HISTORIC AND DESIGN REVIEW COMMISSION

HDRC CASE NO: 2015-116
ADDRESS: 2800 BROADWAY
LEGAL DESCRIPTION: NCB 1055 BLK LOT 7 & SE IRR 292.30 FT OF 9 & NCB 3869 BLK 15 LOT 3, 17 & NW IRR 205.23 FT OF 18 2014 - MERGE PER CR #31995
ZONING: C3NA RIO-1
CITY COUNCIL DIST.: 2
APPLICANT: Mike Reiland/Budget Signs
OWNER: Doseum Childrens Museum
TYPE OF WORK: Signage
REQUEST:

Location Plan & Message Schedule - Site / Exterior

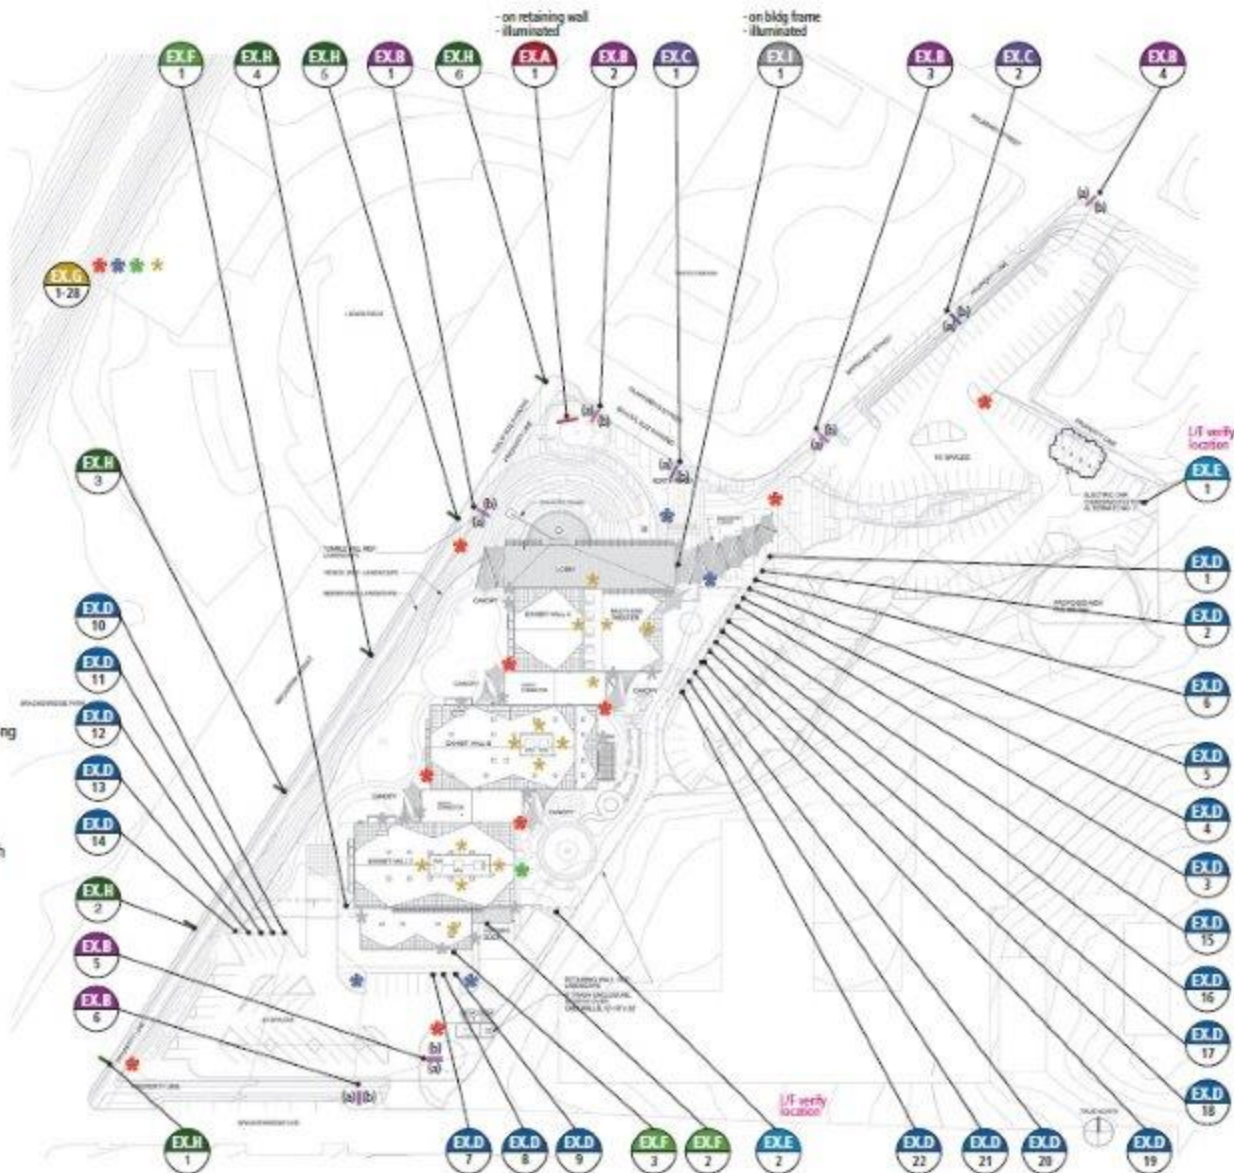
- e. The applicant has provided a master signage plan that shows the placement of the above requested signage, directional signage and various site signage such as parking. This request for a master plan for signage is appropriate and consistent with the UDC. The applicant is responsible for complying with the UDC Section 35-678(f) in regards to additional signage that is allowed that is not included in the total signage area.

Staff recommends approval of items #2 through #5 as submitted based on findings c through e.

Sign Type EXA sign SPECS

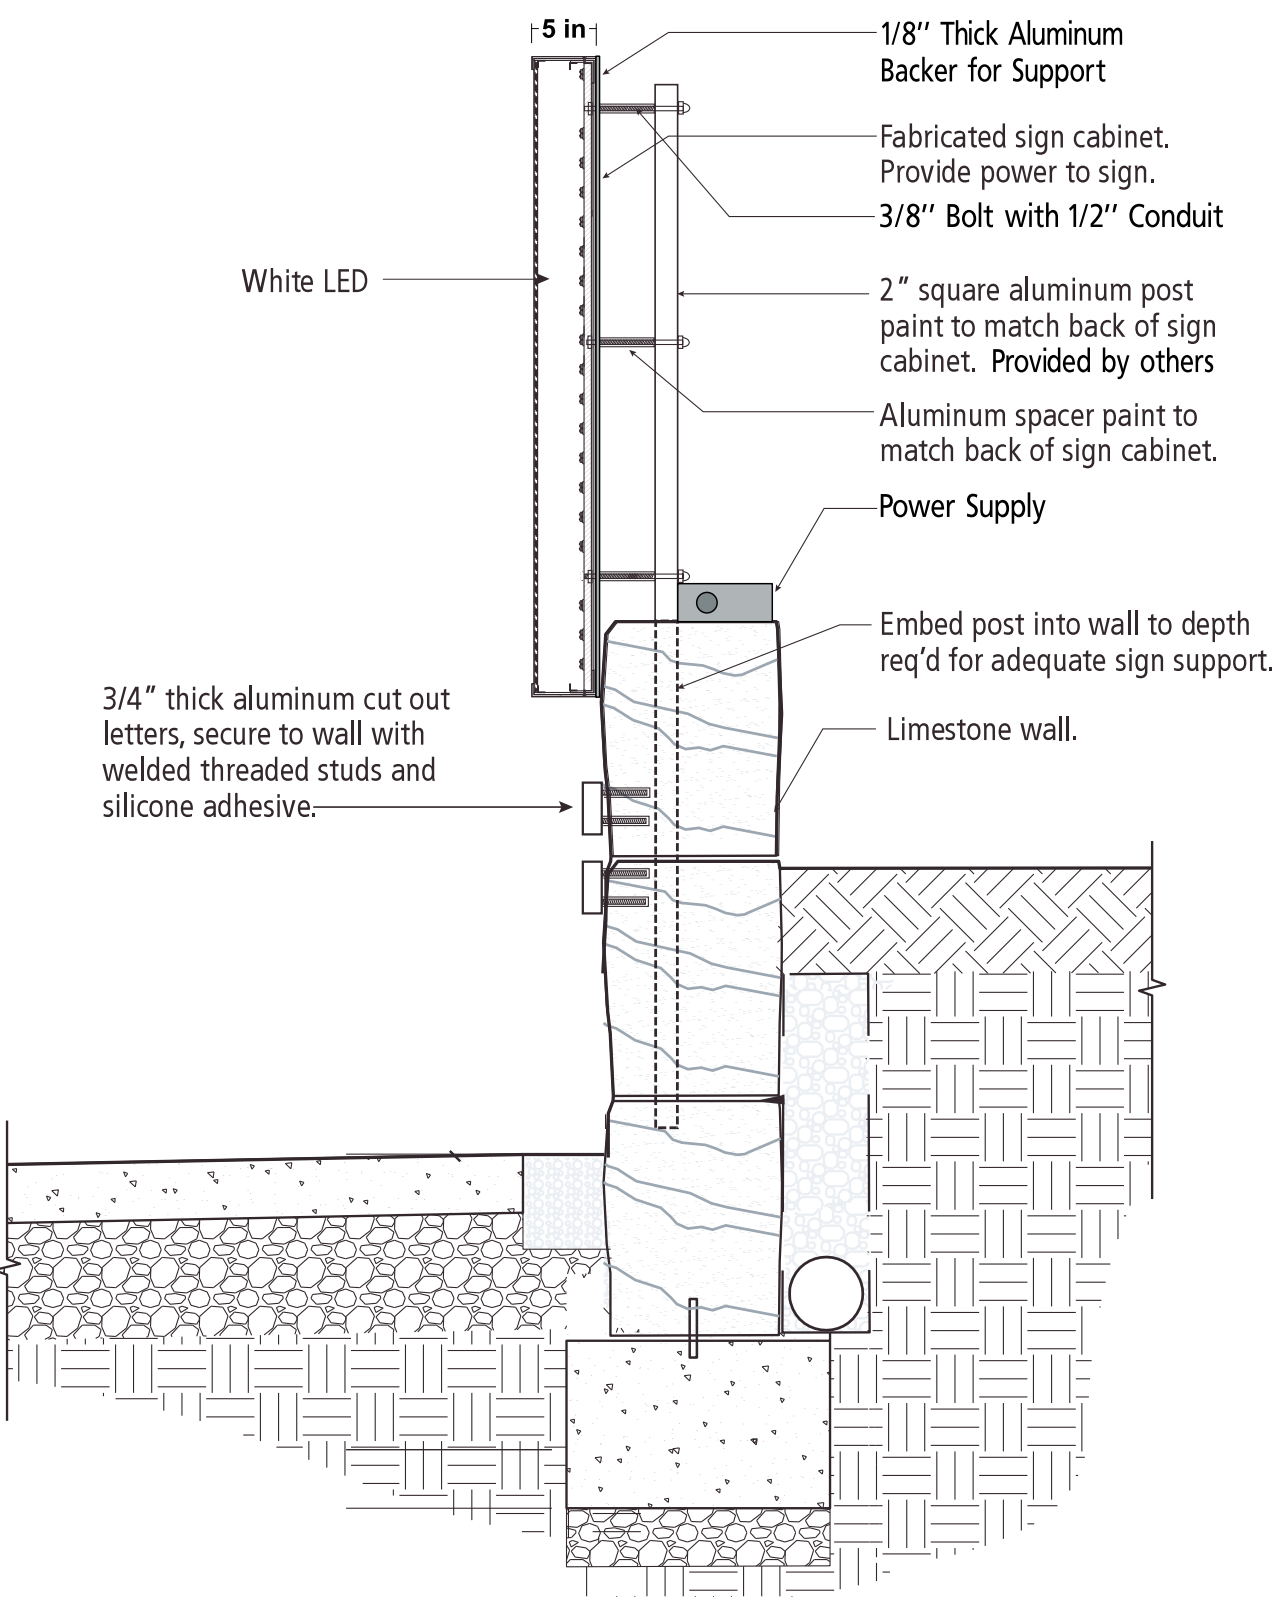
- a. This request was heard by the Design Review Committee on March 24, 2015. At that meeting, committee members expressed concern over the design of the monument sign, particularly the use of channel letters and the proposed lighting design.

- b. The applicant has proposed to install a monument sign at the corner of Broadway and Humphreys. The base for the monument sign will be limestone and will be approximately three (3) feet tall, one (1) foot wide and fifteen (15) feet long. Mounted on the limestone base will be 3.3 inch tall letters which read "San Antonio's Museum for Kids". Above this limestone base, the applicant has proposed to install the "THE DOSEUM" signage which is 8' – 6" at its widest point and approximately 5' – 0" at its tallest. The cabinets for the internally illuminated sign will be five (5) inches deep with one (1) inch aluminum retainers with no seems. The cabinets will be painted and feature returns with white 3/16" acrylic faces with applied translucent vinyl. The letters themselves will be reverse cut vinyl. Given the clash between the limestone base, the vinyl internally illuminated channel letter and the design of the primary structure on the site, staff finds that the proposed monument signage is not consistent with the UDC Section 35-678(c)(1). An aluminum sign with reverse lit channel letters would be more consistent with the three proposed perforated signs that are to read "LEARN", "EXPLORE" and "CREATE".

Staff does not recommend approval of item #1 based on findings a and b. Staff recommends that the applicant consider an aluminum sign to be more consistent with the proposed perforated aluminum signs.

LEARN
EXPLORE
CREATE

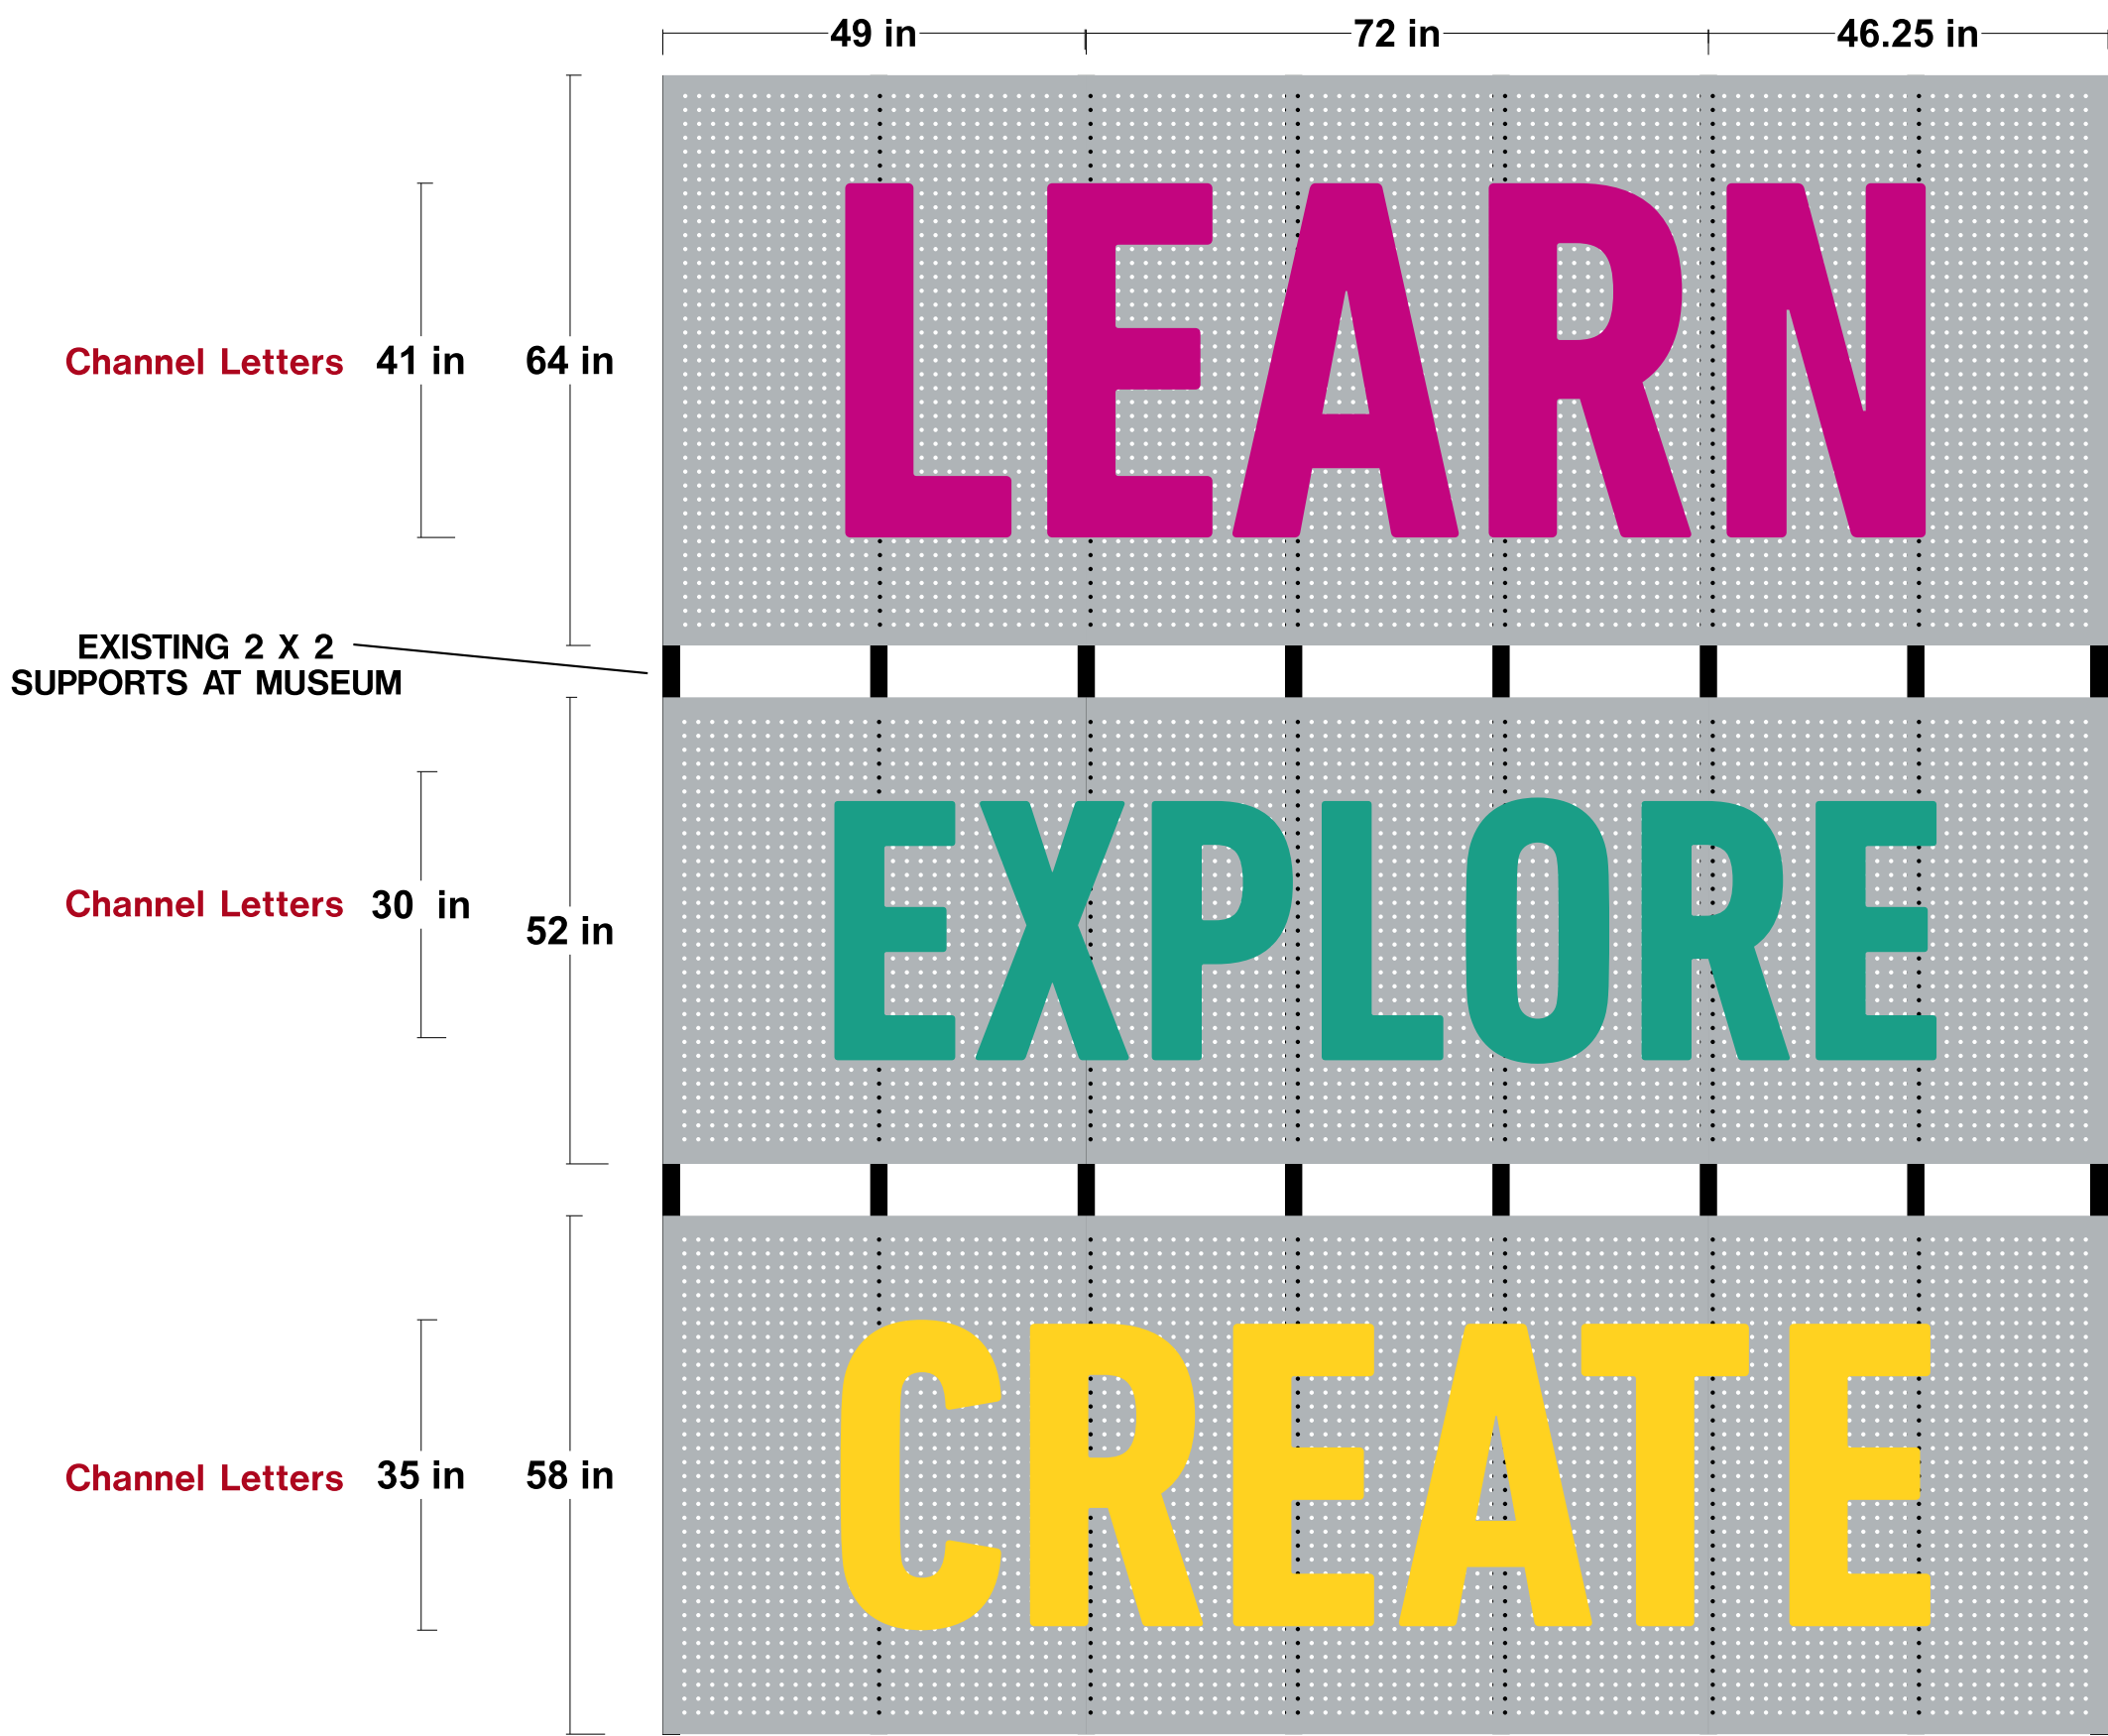
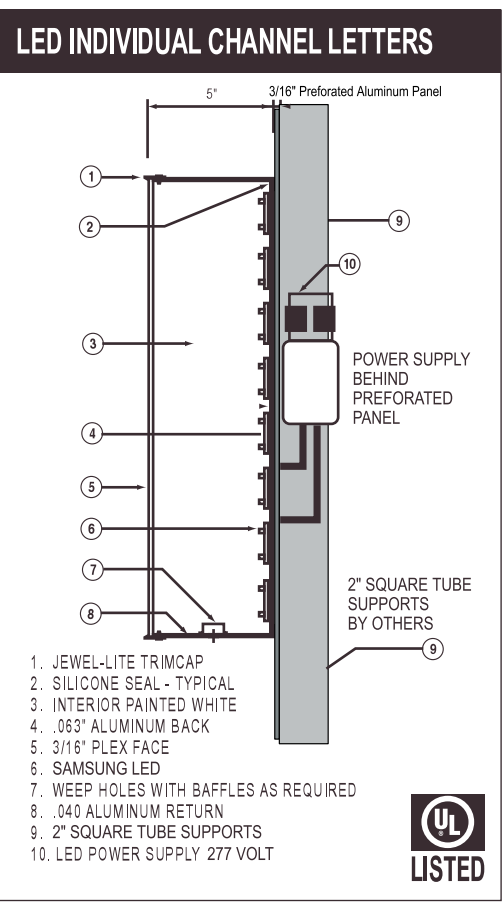
- d. The applicant has proposed to install three perforated aluminum signs that are to read "LEARN", "EXPLORE" AND "CREATE". These signs are designed to address Humphreys, are constructed of materials that are complementary of the primary structure. This is consistent with the UDC Section 35-678(c). Due to the size of the site, staff finds that the request for additional signage is appropriate as specified in UDC Section 35-678(e)(1).
